Enclosure 2

UN#13-057

**Table of Changes to CCNPP Unit 3 COLA Associated with Response to RAI No. 339**

**Table 3.8-3— {Bearing Capacity Evaluation Results for the CBIS}**

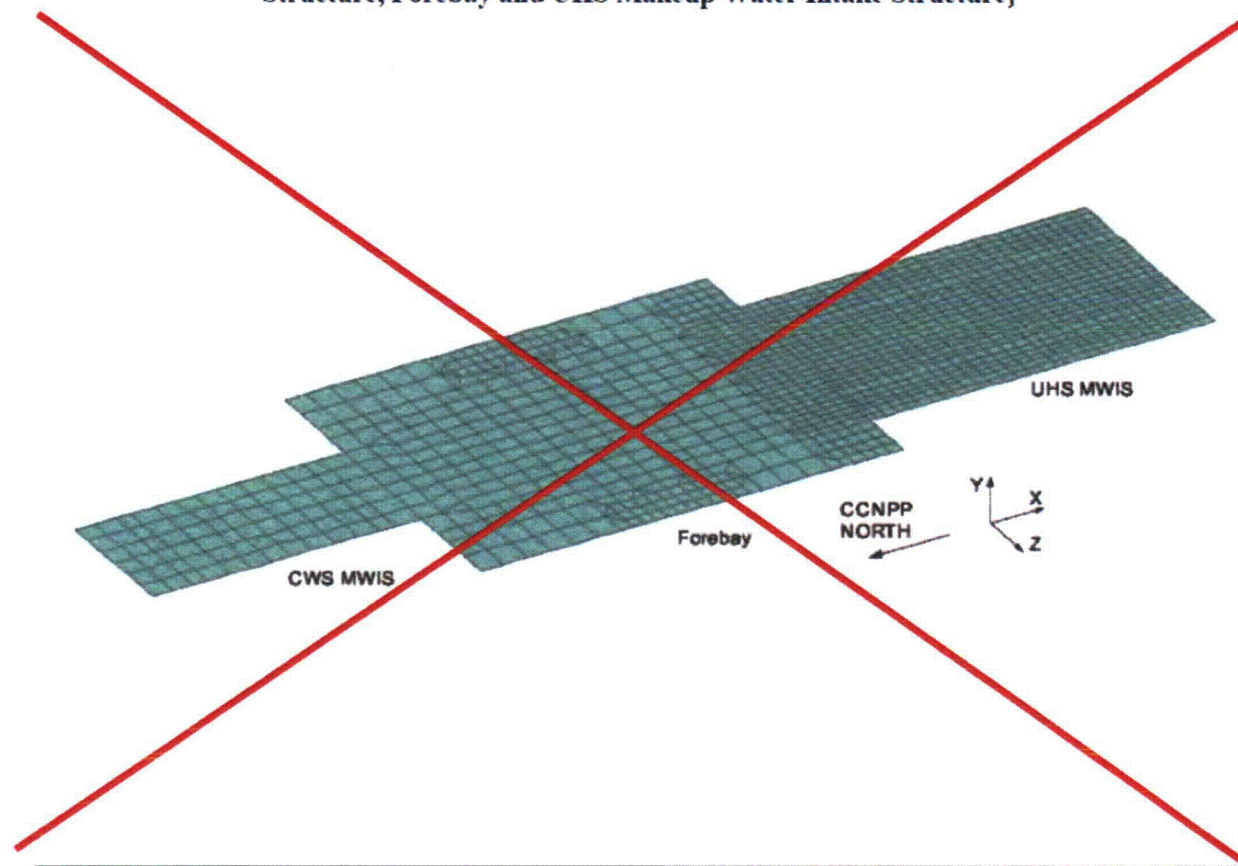
The average bearing pressures across the CBIS basemat and maximum localized pressures for each load combination are provided in ~~Maximum soil bearing pressures under the CBIS foundations are provided in~~ Table 3.8-3.

RAI 339  
03.08.04-34

<u>LOAD COMBINATION</u>	<u>MAXIMUM LOCAL PRESSURE (KSF)</u>	<u>AVERAGE BEARING PRESSURE <sup>(1)</sup> (KSF)</u>	<u>BEARING CAPACITY (KSF)</u>
<u>Static</u>	<u>D + L + F</u>	<u>14.8</u>	<u>5.1</u>	<u>11.7</u>
	<u>D + L + F + W</u>	<u>14.9</u>	<u>5.0</u>	
	<u>D + L + F + Wt</u>	<u>15.6</u>	<u>4.9</u>	
	<u>D + L + F + SPH</u>	<u>14.9</u>	<u>4.9</u>	
	<u>D + L + F + PMH</u>	<u>16.9</u>	<u>4.7</u>	
<u>Seismic</u>	<u>D + L + F + E'</u>	<u>18.6</u>	<u>8.0<sup>(2)</sup></u>	<u>17.6</u>

<sup>(1)</sup> Effective area of the foundation resisting the load is assumed as the 50% of the CBIS basemat area.

<sup>(2)</sup> Effective area of the foundation resisting the load is assumed as the 50% of the CBIS area that is in compression.

**Figure 3.8-5— {Isometric View of the Basemat Finite Element Mesh (STAAD Pro Static Analysis Model) for the CWS Makeup Water Intake Structure, Forebay and UHS Makeup Water Intake Structure}**

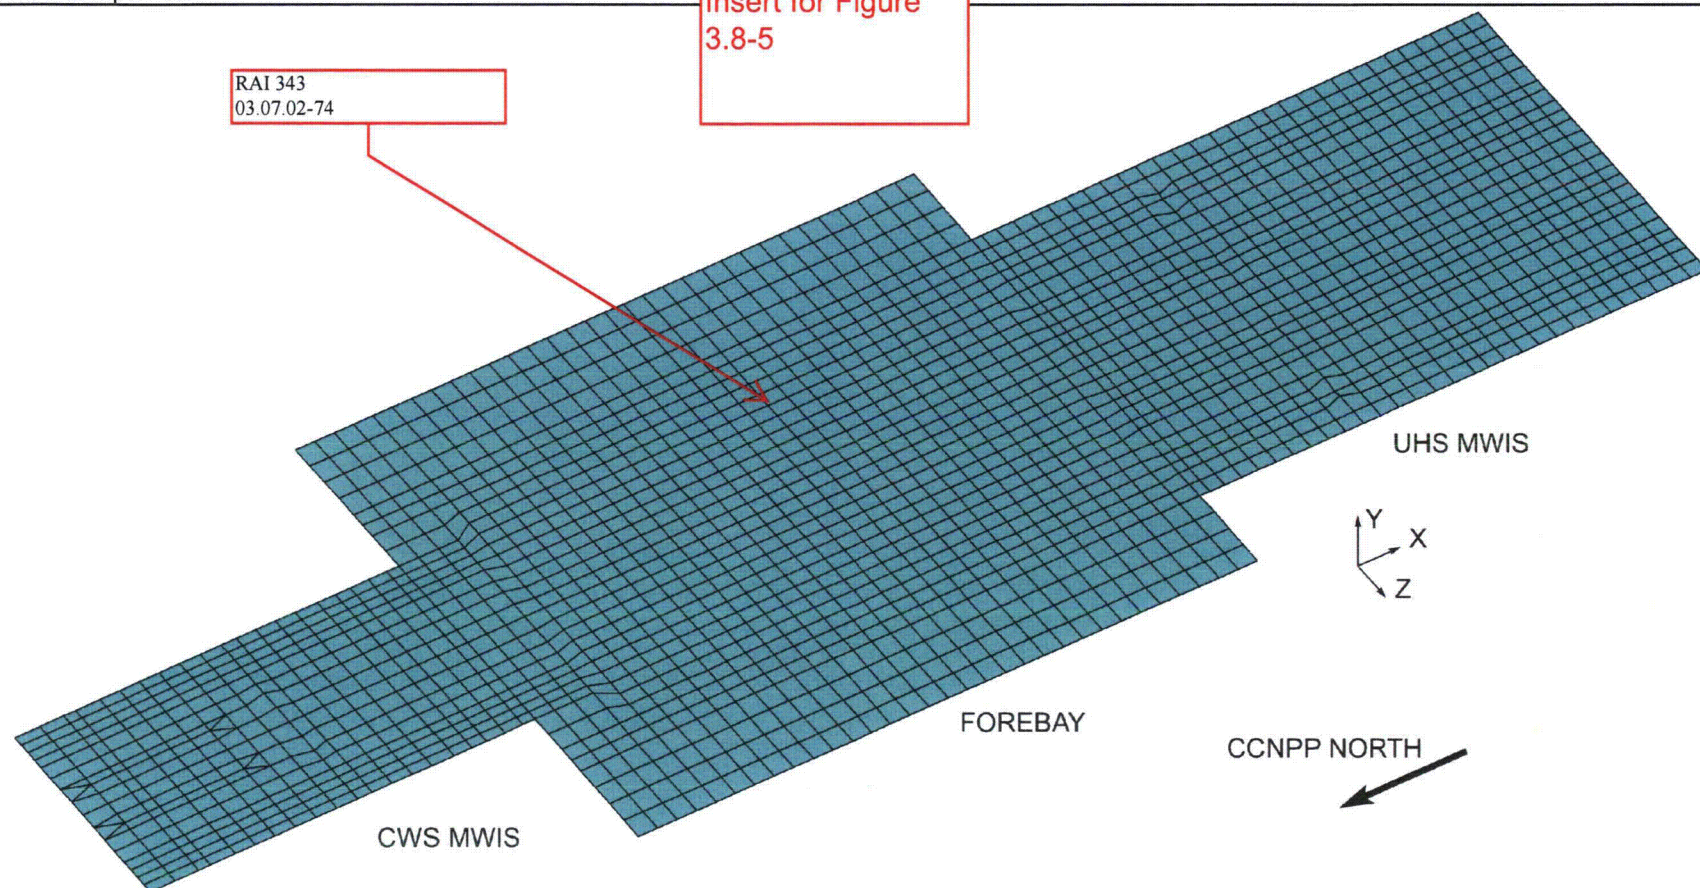
Insert for Figure  
3.8-5

Figure 3E-5— {Isometric View of the Common Basemat Intake Structures STAAD Pro Model for Static Analyses}

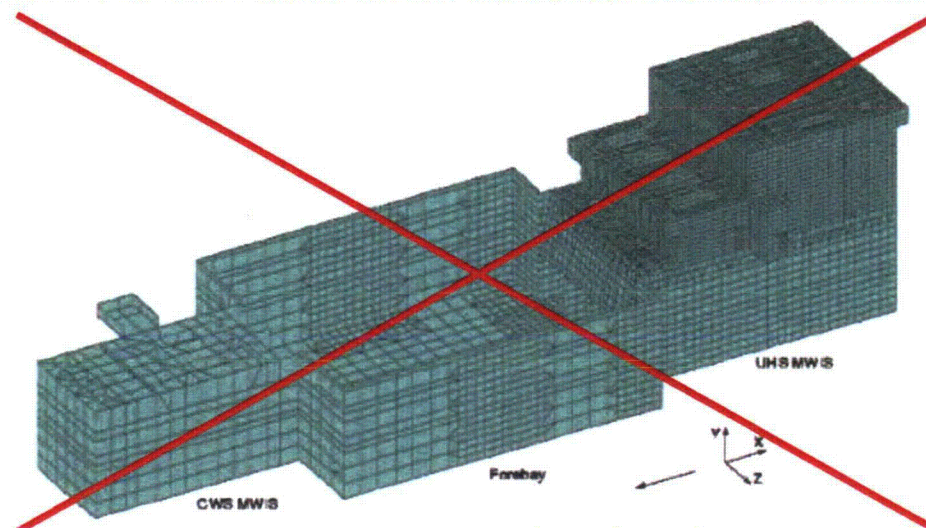
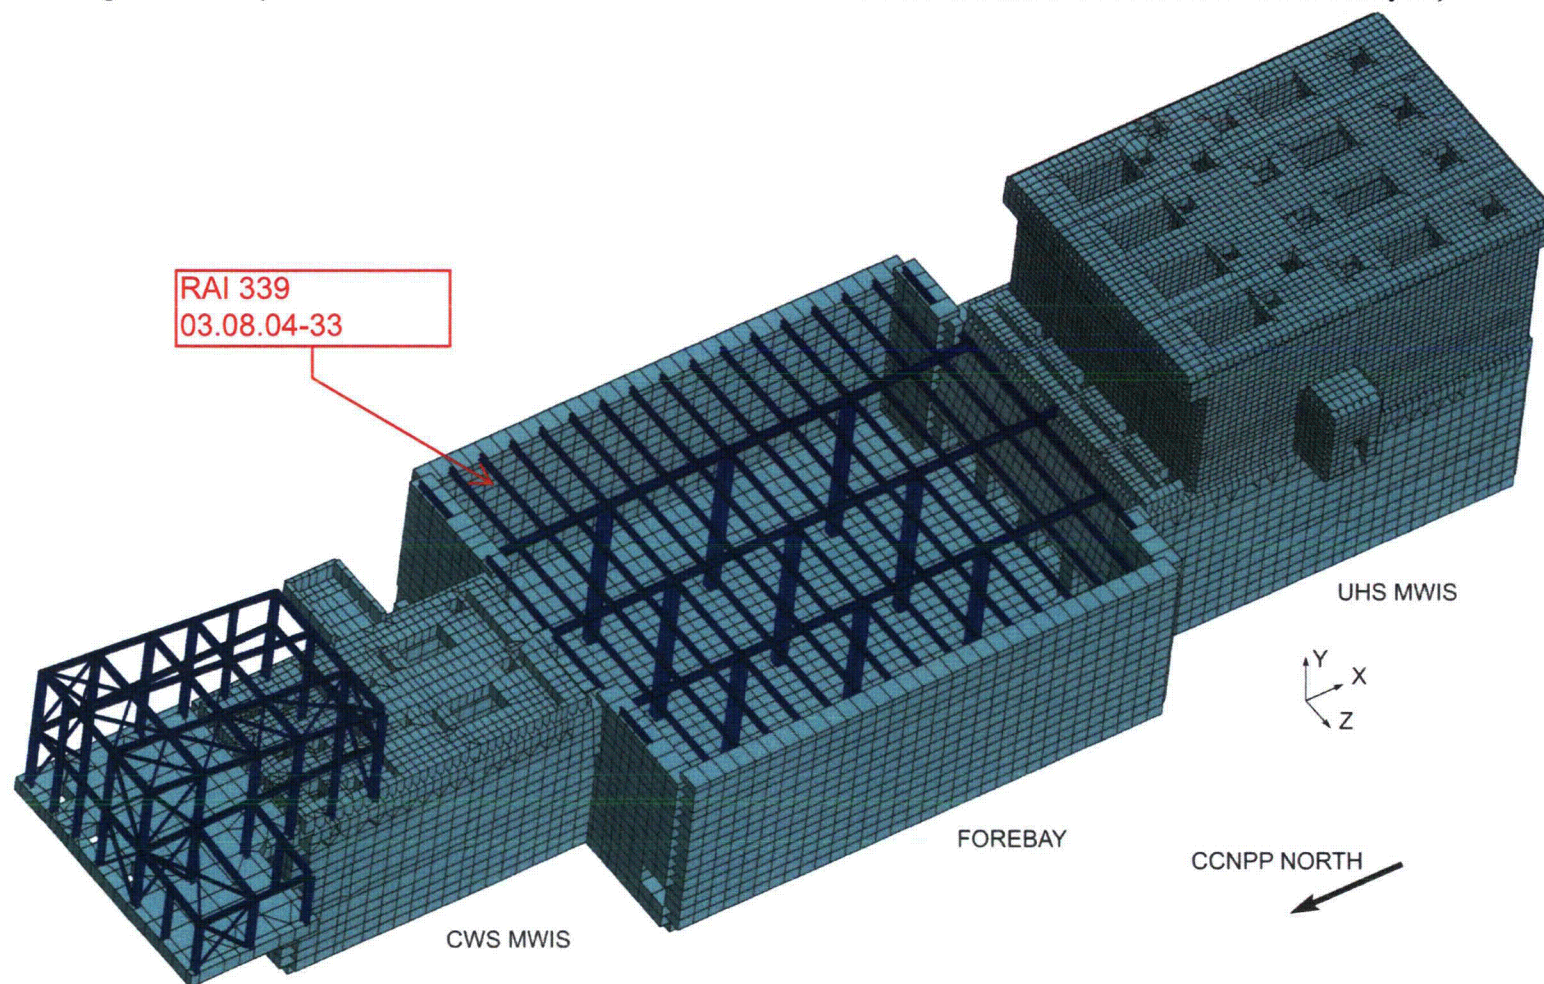
The FE model is described in detail in Section 3.7.2.3. Figure 3.7-23 and Figure 3E-5 depicts the FE model for the static analysis of the CBIS. The entire CBIS is modeled, without assuming a symmetry plane, and the UHS MWIS is modelled in greater detail.
